Model: Stinger-C1 DF (DF68)	Date: 15-Jan-00	No.: MA859001a
-----------------------------	-----------------	----------------

MB Correction

Model: Stinger-C1 DF	Date: 15-Jan-00	No.: MA859002a
----------------------	-----------------	----------------

Modified Article: Platen cover sheet pulls up on exposure glass		Prepared by: K. Miura	
From: Technical Services Dept., GTS Division			
Reason for Modification:	<input type="checkbox"/> Parts catalog correction <input type="checkbox"/> To facilitate assembly <input type="checkbox"/> Part standardization	<input type="checkbox"/> Vendor change <input checked="" type="checkbox"/> To improve reliability <input type="checkbox"/> Other	<input type="checkbox"/> To meet standards ()

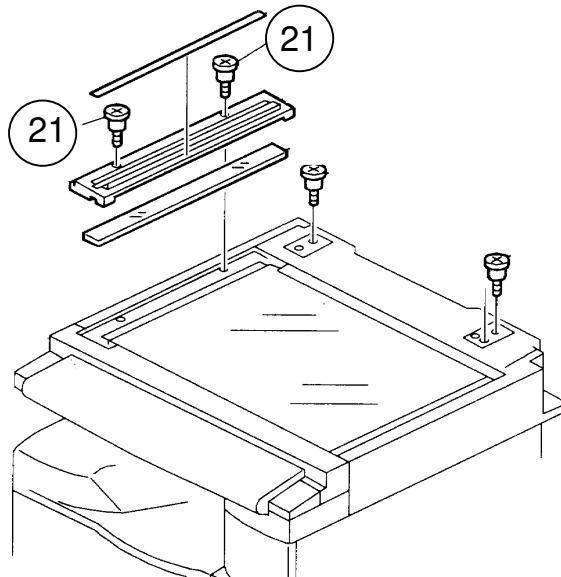
The information announced in MB (MA859001) is incorrect.
Please ignore this MB.

Parts Number Correction

Old part number	New part number	Description	Q'ty	Page	Index	Note
A6283118	A1931759	Stepped Screw	2	3	21

Q'ty Correction

Old Q'ty	New Q'ty	Part number	Description	Q'ty	Page	Index	Note
1	2	A6283115	Stepped Screw	2	3	21

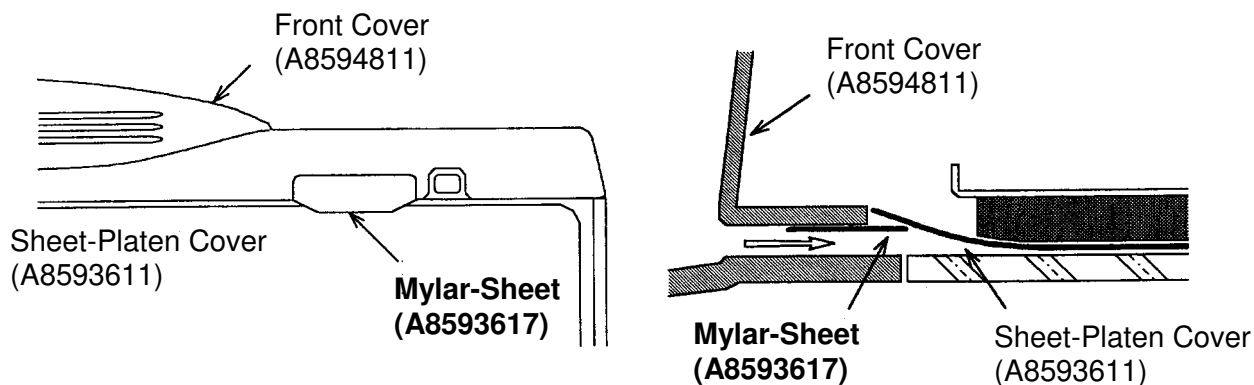
When the platen cover is closed and opened again, the white sheet on the inside of the cover touches the exposure glass and pulls up on the glass.

A sheet of mylar has been attached to the **front cover** to prevent it from touching the glass when the cover is closed (see the illustration).

Old part number	New part number	Description	Q'ty	Int	Page	Index	Note
	A8593617	Mylar – Sheet	1		3	23

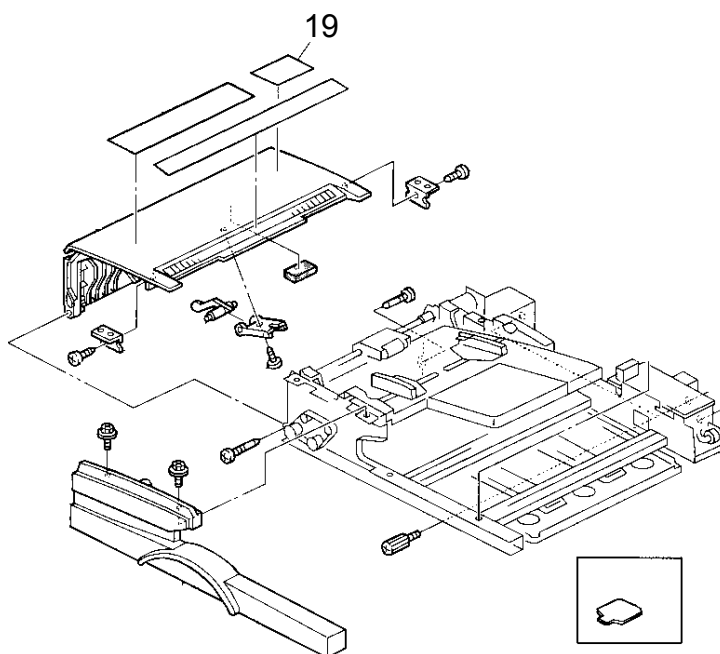
For purposes of parts standardization with existing and new models yet to be released, the exposure glass decal has been changed.

Old part number	New part number	Description	Q'ty	Int	Page	Index	Note
A8596052	A8586062	Decal - Exposure Glass	1	O/O	3 17	19 7

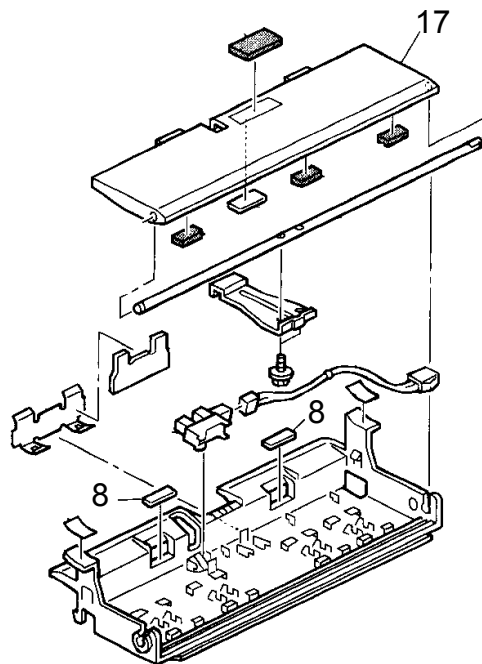
The material of the cushion base has been changed to ensure that #17 (Base - Paper Feed) will separate paper to feed the original smoothly.

Old part number	New part number	Description	Q'ty	Int	Page	Index	Note
A8592318	A8592319	Cushion Base	2	X/O	5	8

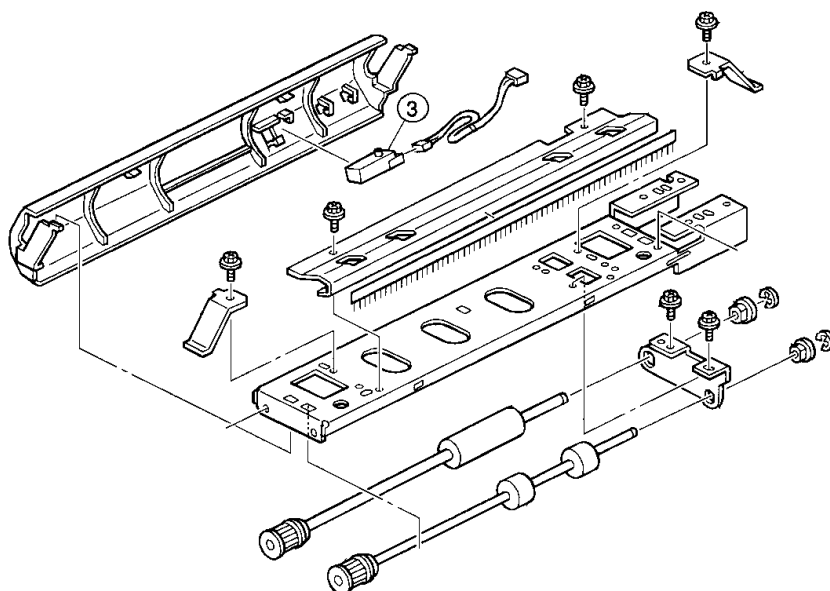
The vender for the following part has been changed.

Old part number	New part number	Description	Q'ty	Int	Page	Index	Note
AW010076	AW010093	Photo Sensor – PS – 117ND1	1	O/O	11	3

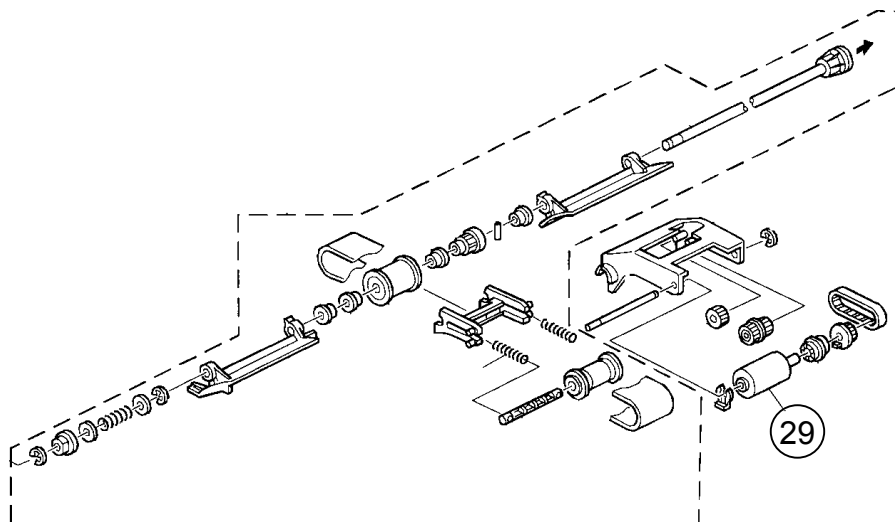
For parts standardization with other models, the pick-up roller has been changed as follows.

Old part number	New part number	Description	Q'ty	Int	Page	Index	Note
A8592161	B3862171	Pickup Roller	1	O/O	7	29

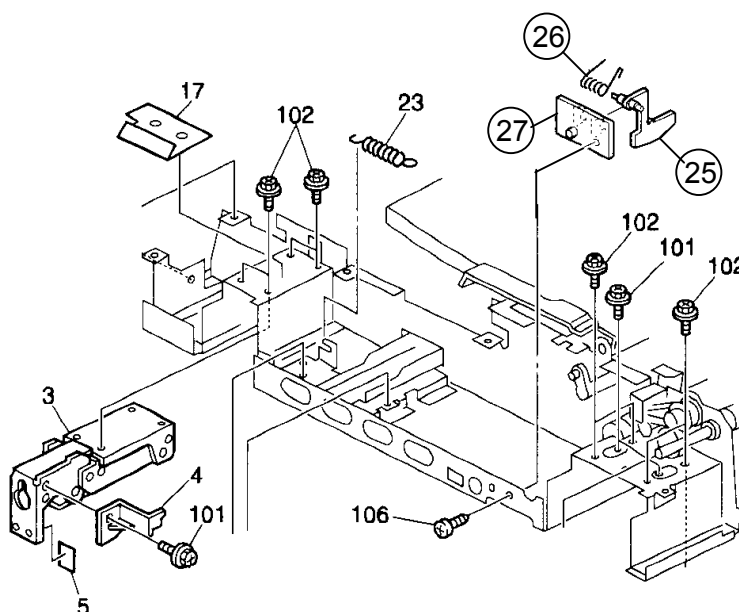
If large originals are set on the exposure glass under the APS Feeler, the feeler can damage the original when the ADF is closed.

The two fused sections of the Feeler (#25, 27 below) have been separated and a spring added so that the Feeler will retract inside the DF upon contact.

Old part number	New part number	Description	Q'ty	Int	Page	Index	Note
A8591121		Feeler – APS	1	X/O	13	24	
	B3861125	APS Feeler	1		13	25	A
	B3871951	Spring – Paper Size Sensor	1		13	26	A
	B3861121	APS Feeler Bracket	1		13	27	A

Note: These three parts should be replaced together as a set.

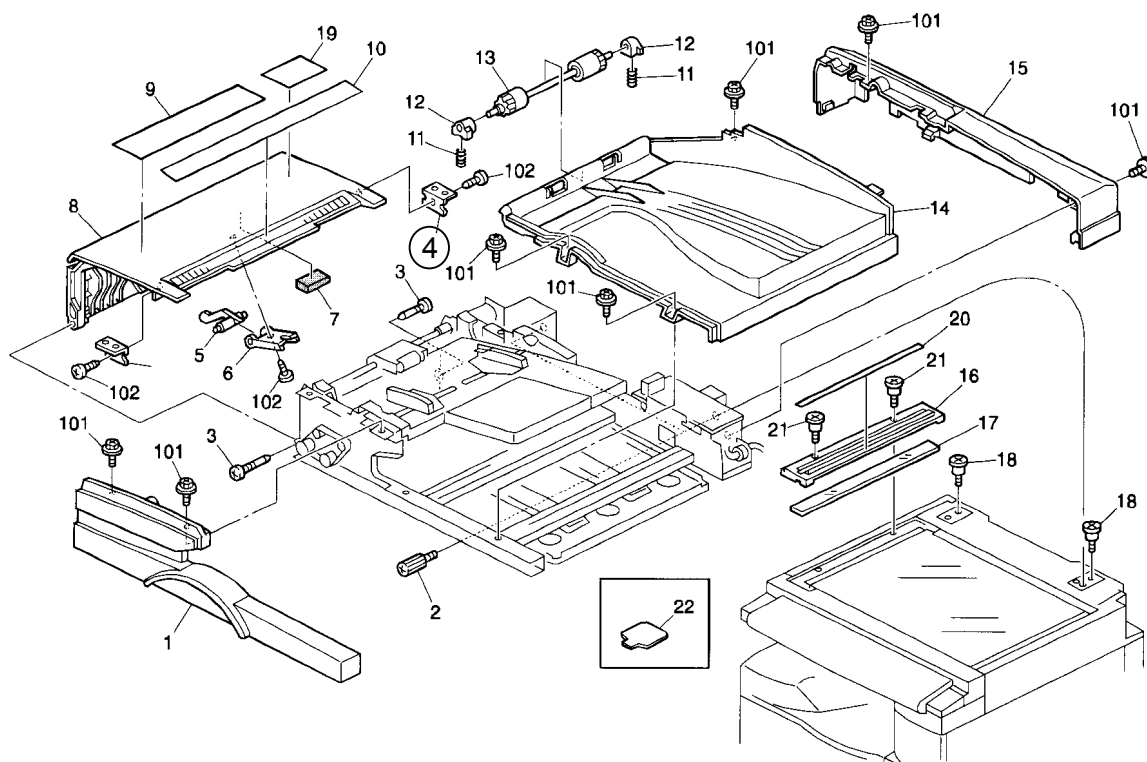
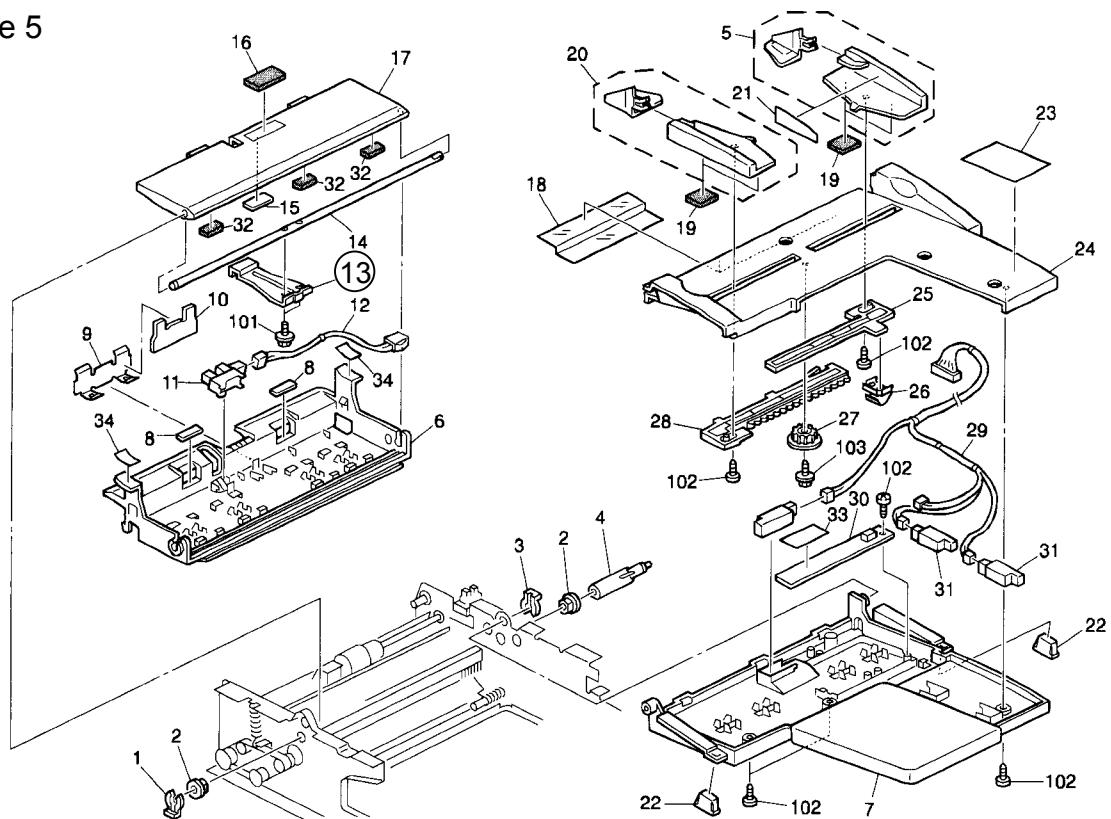
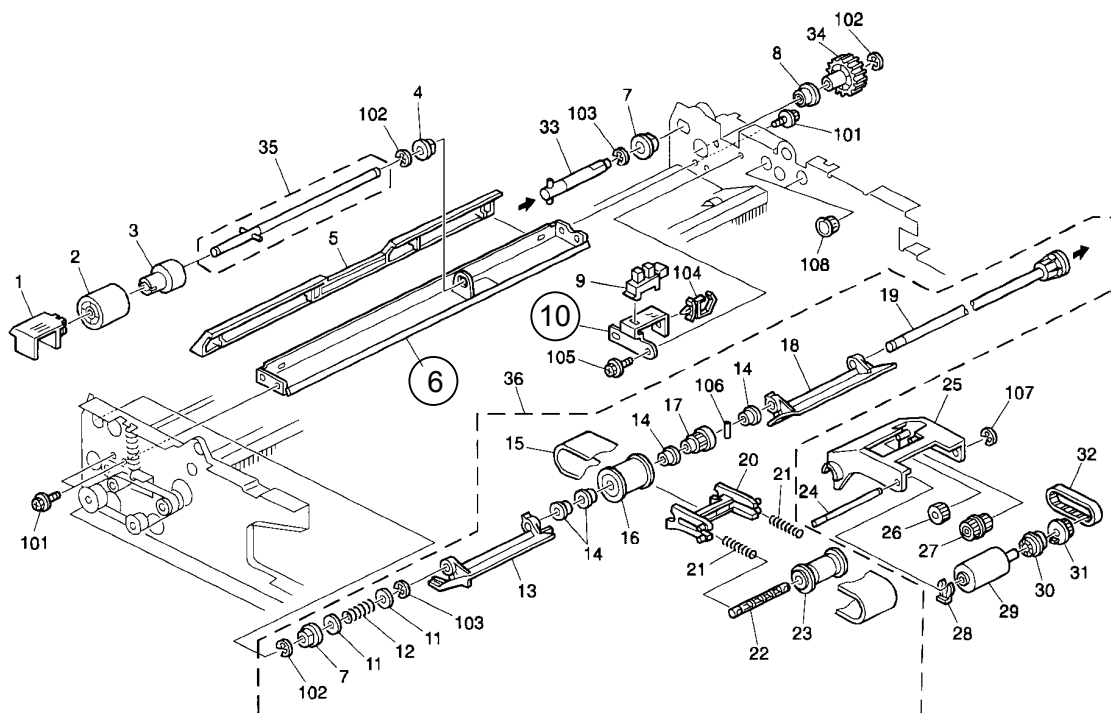
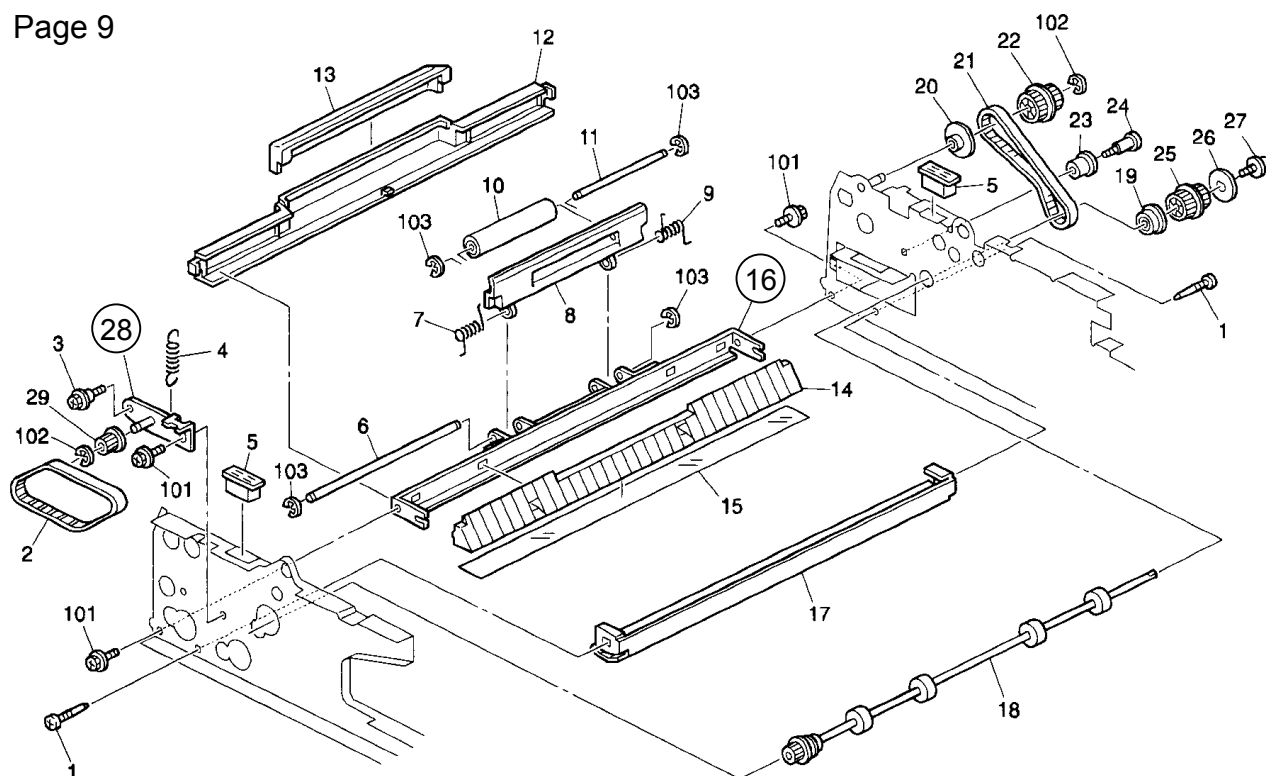
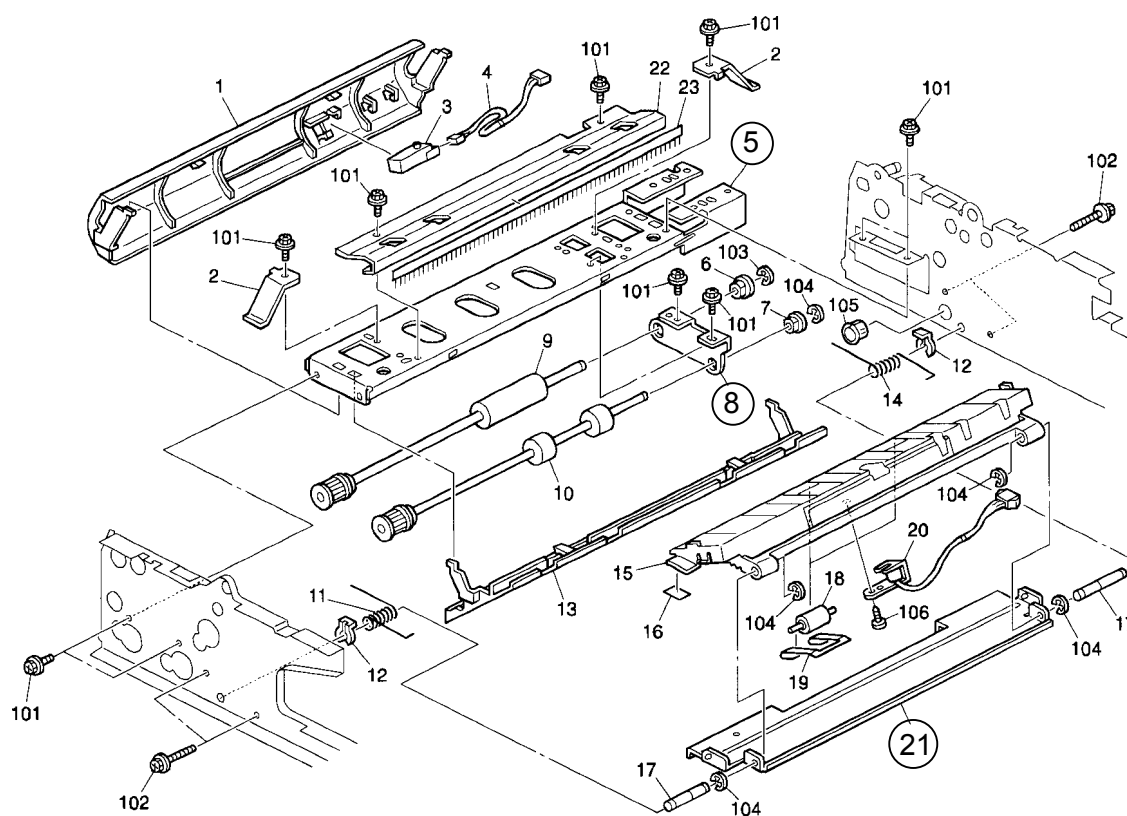
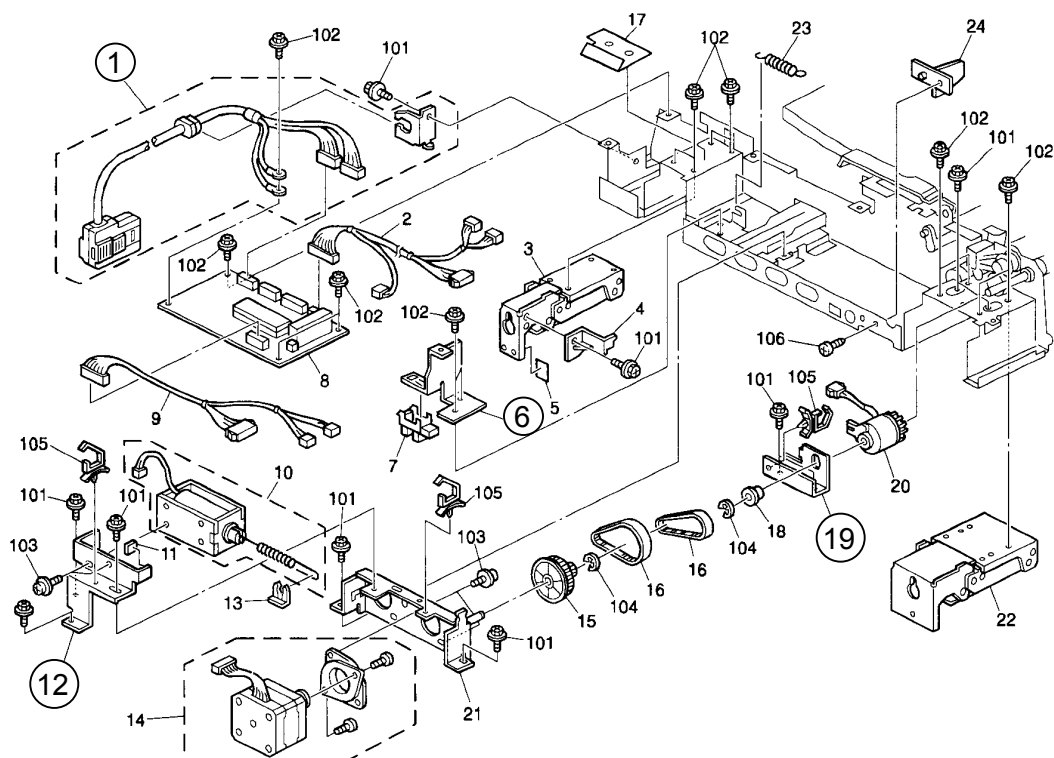
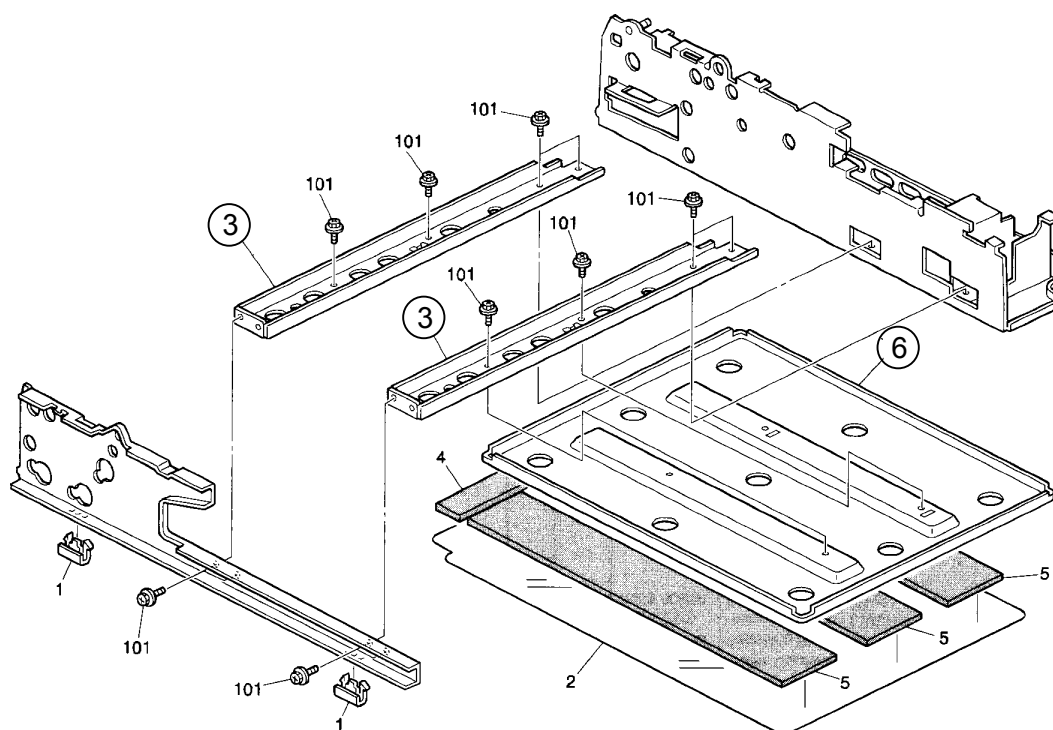
The material for all brackets in the table below has been changed, and in accordance with this, the P/N for all other parts listed has also been changed.

Old part number	New part number	Description	Q'ty	Int	Page	Index	Note
A8594873	B3864873	Positioning Plate	2	O/O	3	4	
A8592353	B3862353	Pressure Plate – Base	1	O/O	5	13	
A8591610	B3861610	Separation Stay	1	O/O	7	6	
A8591123	B3861123	Sensor Bracket	1	O/O	7	10	
A8591710	B3861710	Left Lower Stay	1	O/O	9	16	
A8594311	B3864311	Adjusting Pin	1	O/O	9	28	
A8591311	B3861311	Left Stay	1	O/O	11	5	
A8591320	B3861320	Bracket - Transport Roller	1	O/O	11	8	
A8593413	B3863413	Cover - Exit Guide Plate	1	O/O	11	21	
A8595800	B3795800	Harness - Interface	1	O/O	13	1	
A8591122	B3861122	Right Sensor Bracket	1	O/O	13	6	
A8594411	B3864411	Bracket – Solenoid	1	O/O	13	12	
A8591315	B3861315	Bracket – Electromagnetic Clutch	1	O/O	13	19	
A8591511	B3861511	Middle Stay	2	O/O	15	3	
A8593615	B3863615	Base - Platen Cover	1	O/O	15	6

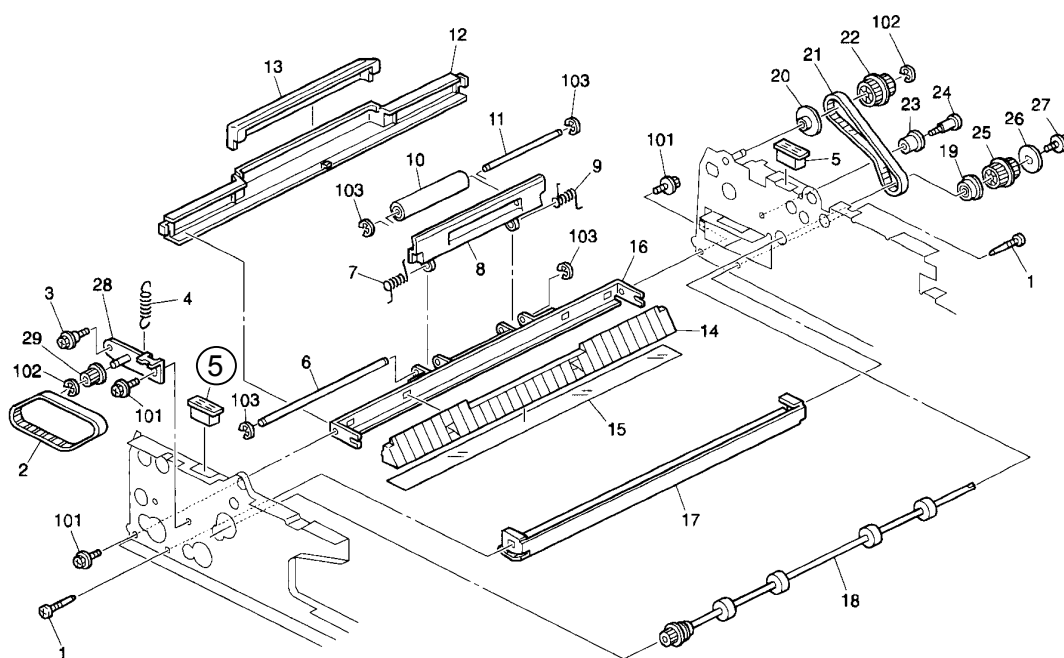
The following part has been changed due to a vendor change:

Old part number	New part number	Description	Q'ty	Int	Page	Index	Note
A8591181		Magnet Catch	1		9	5	
	B3514135	Magnet Catch - Original Table	1	O/O	9	5
